An Coimisiún Pleanála Case Reference: ABP-319866-24 (OA29N.319866)

Sustainable Windfarm Environmental Group (SWEG)

Observations on the Significant Further Information

North Irish Sea Array (NISA) Offshore Wind Farm

Figure 9. SWEG's alternative layouts within the Maritime Area Consent area, for 500 MW (left) and 700 MW (right), each keeping turbines at least 15 km from Rockabill (maps prepared for SWEG by architecture graduate Shauna Murphy)

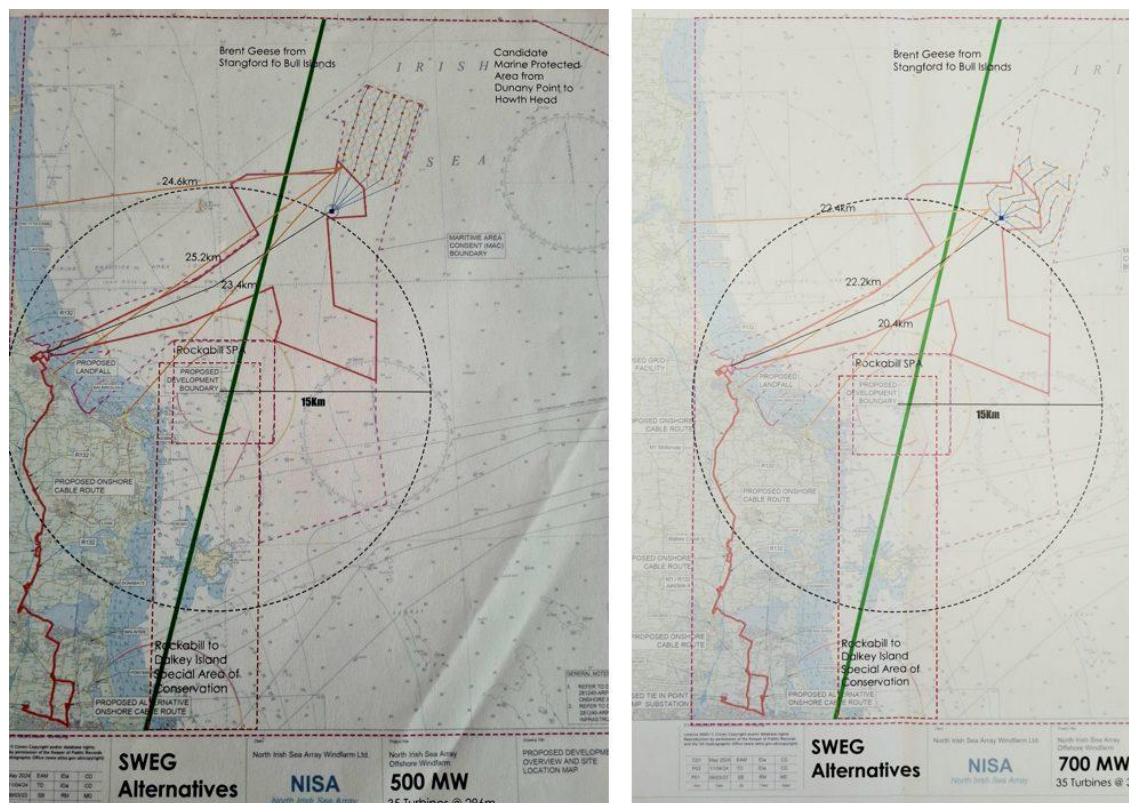
water depths (Figure 9). These were presented to local councillors. We put them forward only as a compromise, if the Commission does not accept that the project should be refused at this location (see Section 1.4.3).
